An  
Coimisiún  
Pleanála

## Inspector's Report

**ABP-322055-25**

Application for a discharge licence under section 4 of the Local Government (Water Pollution) Act 1977 and Regulations 1978 as amended.

**Figure 6.2 Concentration of Ammonia (mg/L NH<sub>4</sub>-N) in GW3 over 177 days in 2024**

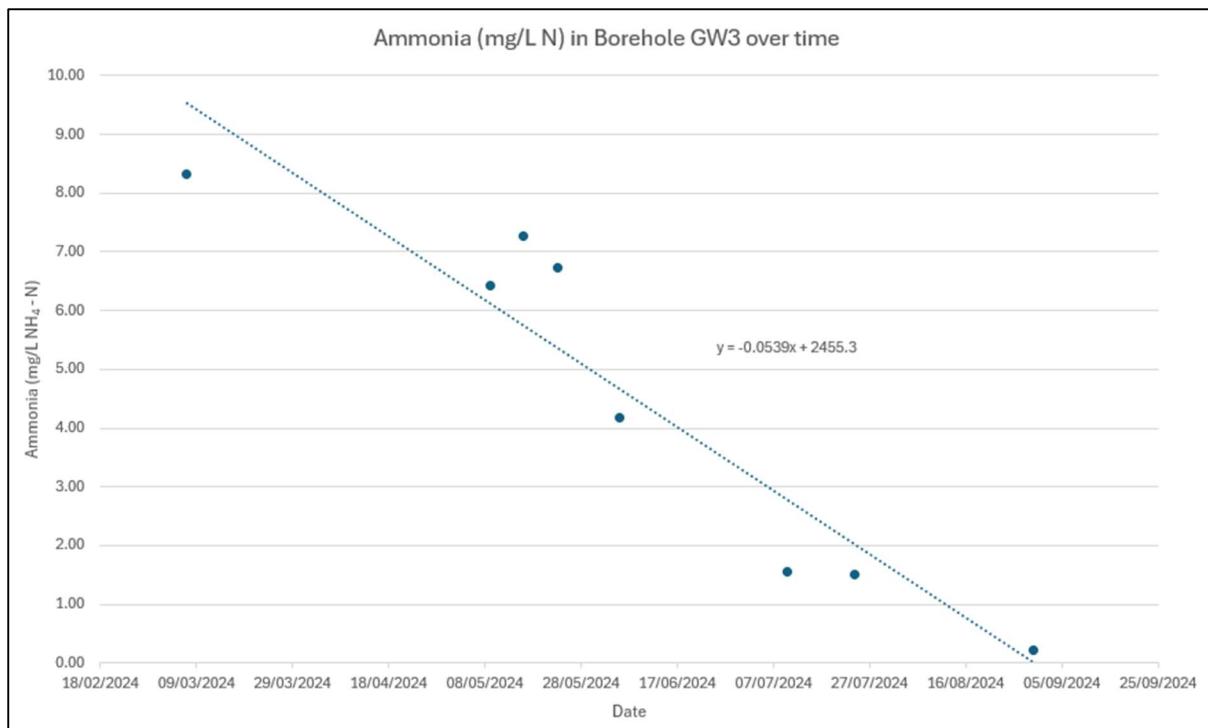
6.6.25. I carried out an assessment of this reduction in ammonia levels in GW3 to estimate when the levels would reduce to background concentrations. The monitoring data for GW3 ammonia results for this period was plotted against time and a trendline calculated (see figure 6.2 below). Using the equation of this line, it was estimated that the concentration of ammonia within GW3 could return to background levels (assumed to be 0.032 mg/L NH<sub>4</sub>-N) by September 20<sup>th</sup>, 2024, assuming the same rate of depletion/attenuation within the borehole. The assumption that the attenuation/depletion rate remains constant is dependent on several factors such as the performance of the treatment system, removal rates of raw wastewater for treatment off-site, rainfall amounts, groundwater flow rates etc. This timeframe is not definitive but can be taken as indicative based on the data provided in the report.

Figure 6.3 The sampling locations relative to the WWTS on the Kippure site

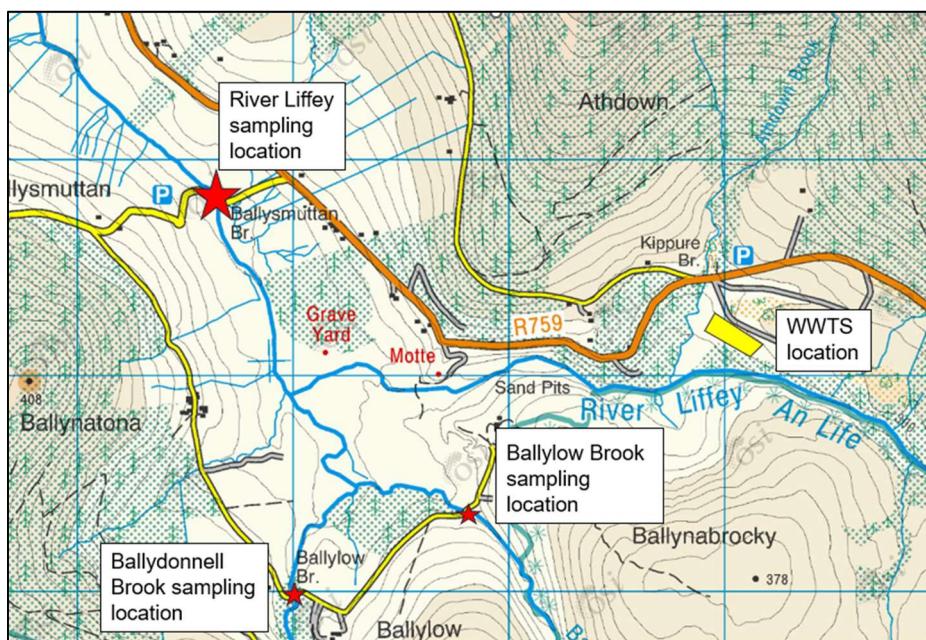
6.6.32. To verify this conclusion relating to the receiving waters of the river Liffey I carried out a desktop-based investigation using available data from the EPA's water quality monitoring programme. I identified a sampling location at Ballysmuttan Bridge (Site code IE\_EA\_09L010200) which is approximately 3km downstream of the Kippure site. This site is routinely sampled as part of the operational water quality monitoring programme managed by the EPA. The location of this monitoring station is appropriate to assess any significant changes in water quality observed in the river Liffey in the vicinity of the site in question over the previous 7 years. Two smaller watercourses, the Ballylow Brook\_010 and the Ballydonnell Brook\_010 flow from the south, join into one watercourse which flows into the river Liffey between the Kippure site and the monitoring location at Ballysmuttan Bridge. I chose the period from 2017 to 2024 (inclusive) as an appropriate time frame for this assessment. See Figure 6.3 below for details of the sampling locations used by the EPA.

Figure 6.4 Ammonia concentration readings at Ballysmuttan Bridge (2017 – 2024)

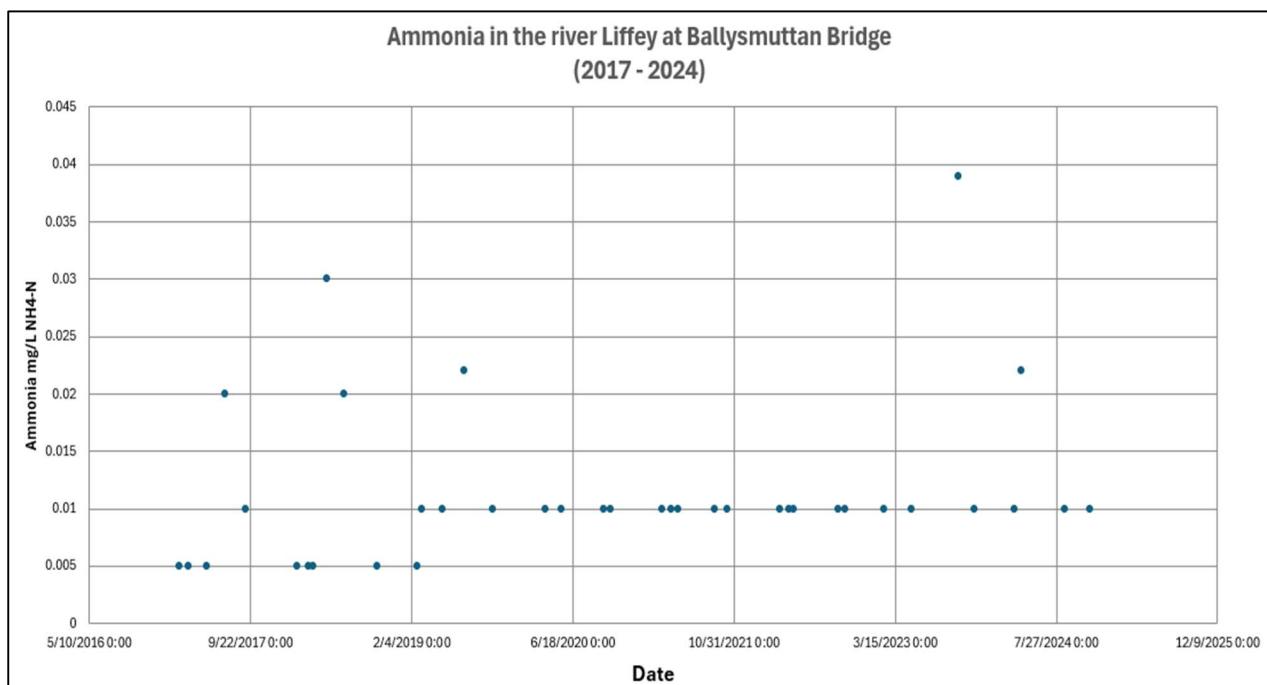
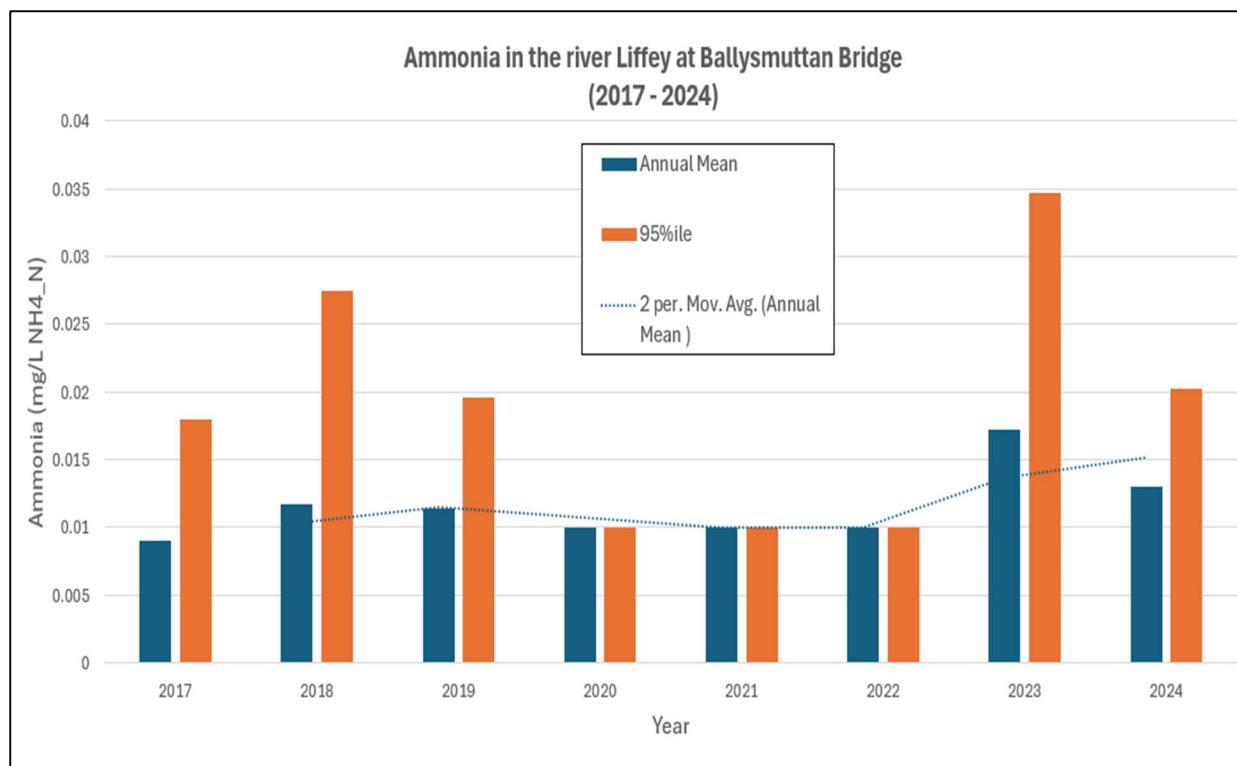
6.6.34. The ammonia data for Ballysmuttan Bridge was assessed and is presented in figures 6.4 and 6.5 below. The data for 2017 to 2024 shows that ammonia levels at Ballysmuttan Bridge have often been below the limit of detection (0.02 mg/l N) for the analysis of ammonia indicating a predominately low-ammonia environment is present in the river Liffey at this location. Occasional readings > 0.02mg/L N have been noted since 2017 and one reading >0.035mg/L N recorded in September 2023.

6.6.35. When the annual averages and 95%ile values were calculated it suggested that the annual values have increased in 2023 and 2024 compared to the previous 5 years. However, most samples taken over this period were below the limit of detection, and the inclusion of one higher sample result can have a significant impact on the average values when sampling takes place 4 or 5 times per year. In the 2023 and 2024 sampling period, 6 out of the 8 samples taken had ammonia values below the limit of detection.

**Figure 6.6 Total Oxidised Nitrogen concentration readings at Ballysmuttan Bridge (2017 – 2024)**

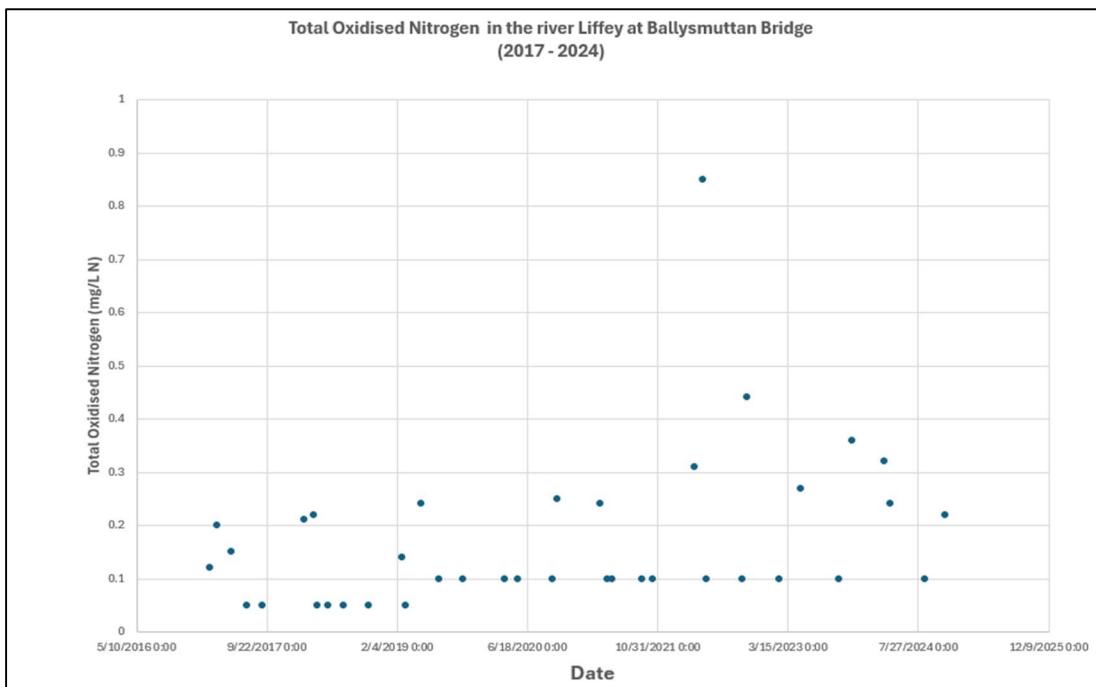
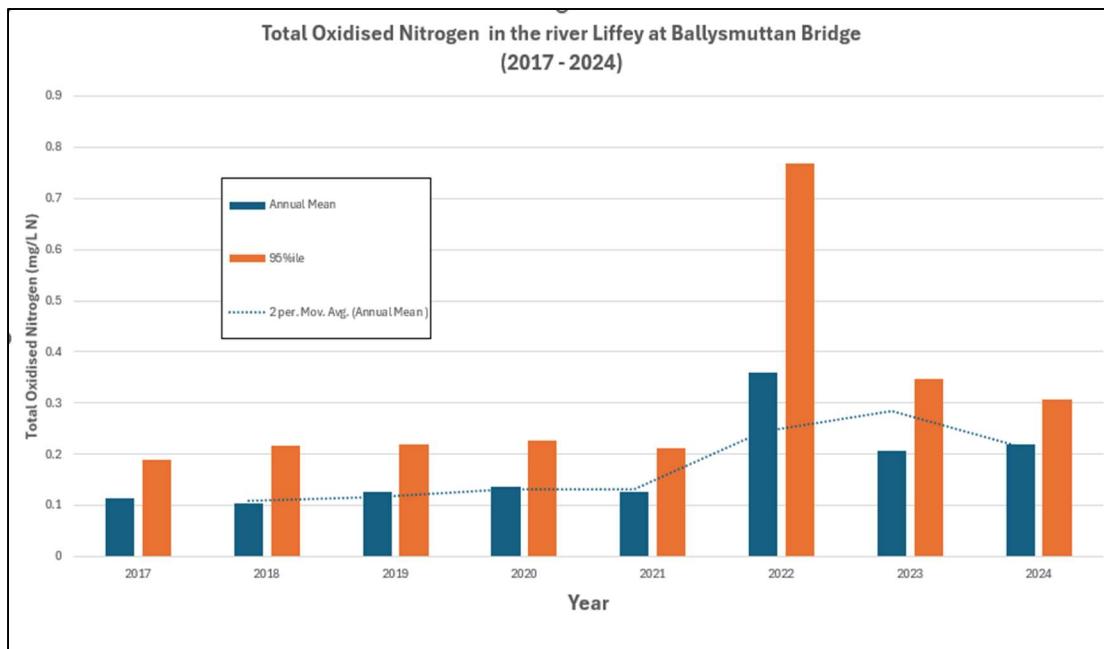
6.6.38. The Total Oxidised Nitrogen (TON) data for the river Liffey at Ballysmuttan Bridge was assessed and is presented in figures 6.6 and 6.7 below. The data for 2017 to 2024 showed that TON results at Ballysmuttan Bridge have often been below the limit of detection indicating a predominately low-oxidised nitrogen environment is present in the river Liffey at this location. Occasional readings  $> 0.02\text{mg/L N}$  have been noted since 2017 with one reading of  $0.85\text{mg/L N}$  in 2022. The data presented in Figure 6.6 indicates that the levels of TON may have increased at this location since 2022.

When the TON annual averages were calculated along with the 95%ile values for the same periods, it confirms that the annual average values have increased in 2022, 2023 and 2024 compared to the previous 5 years.

There are no threshold values for TON or Nitrates in the Surface Water Regulations however a value of  $1.8\text{mg NO}_3\text{-N}$  is used by the EPA as the level at which impacts to the ecological health of rivers and associated downstream marine waters occurs. The annual average TON values noted in the river Liffey at Ballysmuttan Bridge in the period in question although increased, were generally below this value by a factor of 5 or more.

**Figure 6.8 Ortho-phosphate concentration readings at Ballysmuttan Bridge (2017 – 2024)**

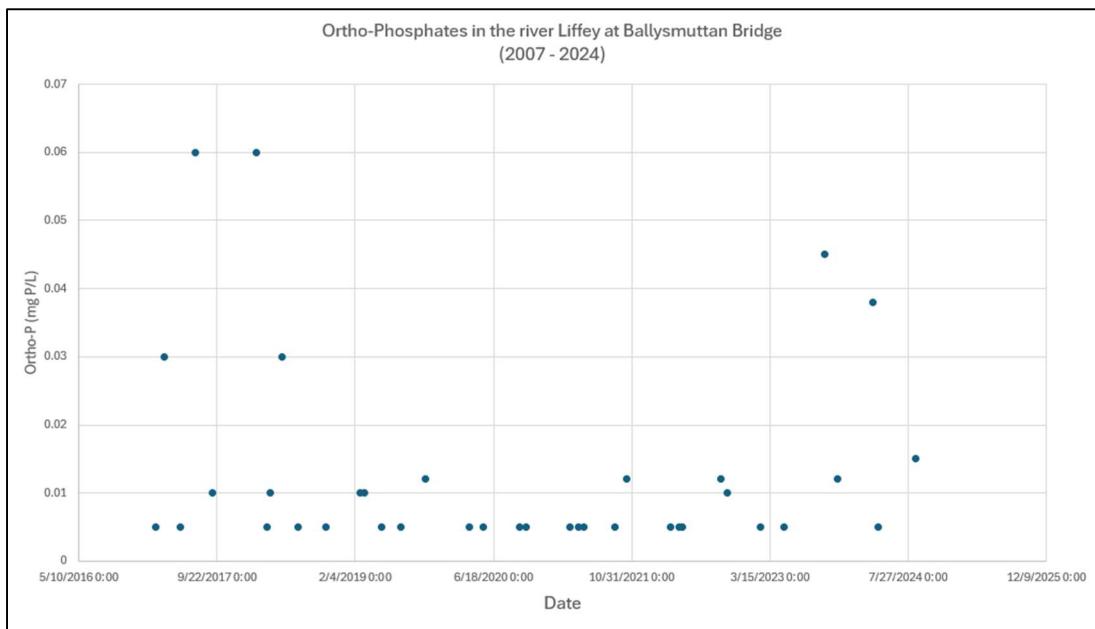
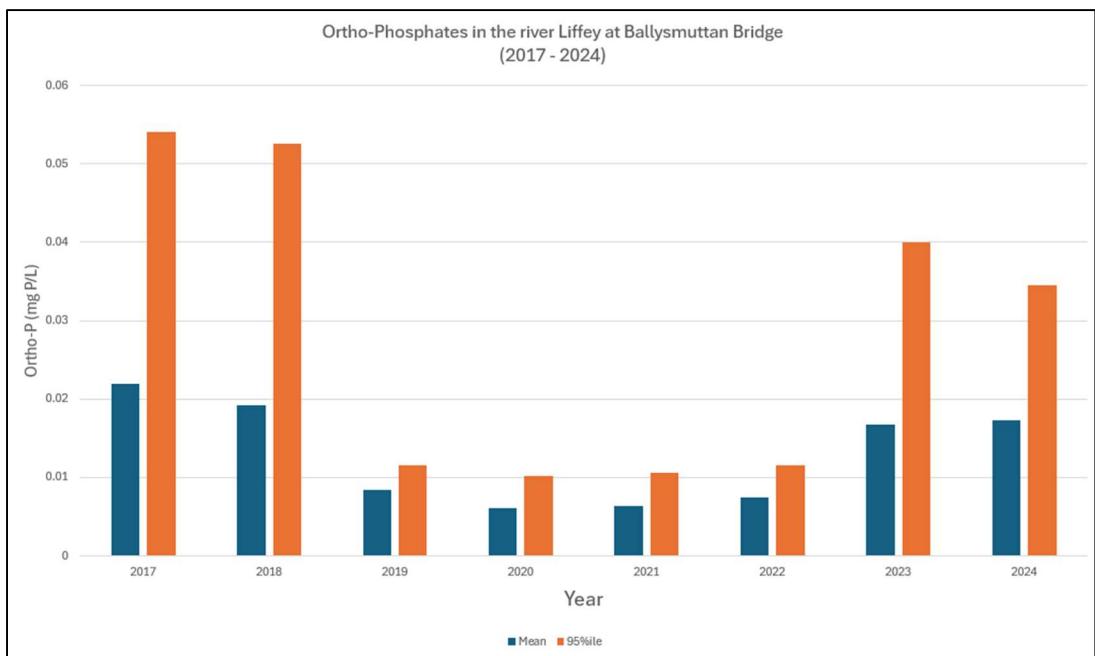
When the annual averages were calculated along with 95%ile values for the same periods, it suggests that the annual average values have increased in 2023 and 2024 compared to the previous 4 years. However, 5 of the 8 samples taken over these 2 years were either below the limit of detection or within 20% of the limit of detection.

The annual averages and 95%ile values are indicative of a 'High Status' river waterbody being less than the Surface Water Regulations threshold values of  $\leq 0.025\text{ mgP/l}$  and  $\leq 0.040\text{ mgP/l}$  respectively for Molybdate Reactive Phosphorous (Ortho-phosphate).

**Figure 6.10 Q-Value results for the river Liffey at Ballysmuttan Bridge (1988 – 2022)**

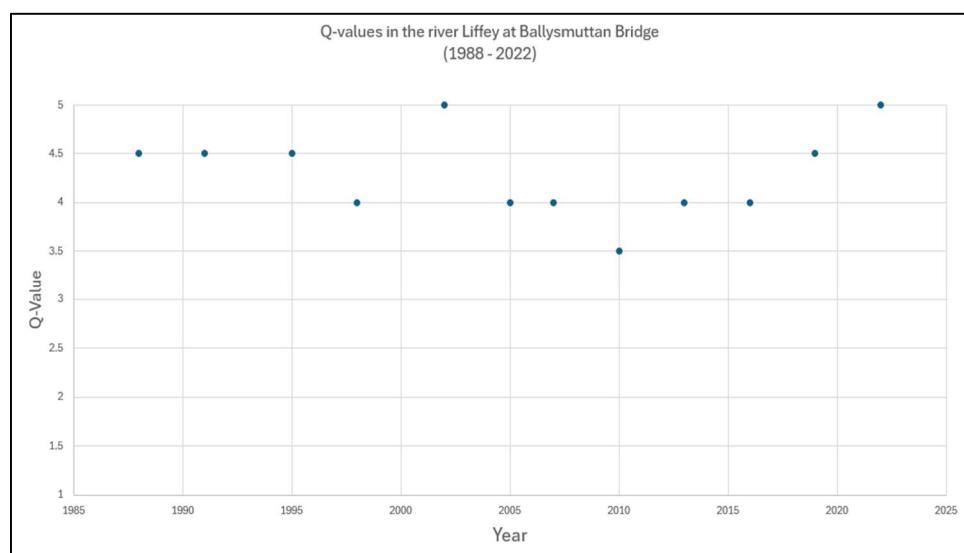
6.6.45. In addition to the nutrient data discussed above, I also assessed the available biological monitoring data (Q-values) as recorded by the EPA for the station at Ballysmuttan Bridge from 1988 to 2022. In 2010 the Q-value was recorded as 3-4 but all other samples over the 34-year period were Q4 or higher and the most recent sampling in 2022 showed the site was of 'High Status' having a Q-value of 5, which is the highest possible value. This data is presented in figure 6.10 below. This indicates that the water quality in the river Liffey downstream of the Kippure site at Ballysmuttan Bridge has historically been of good or high status and shows no signs of being impacted by the presence of the existing wastewater treatment system.
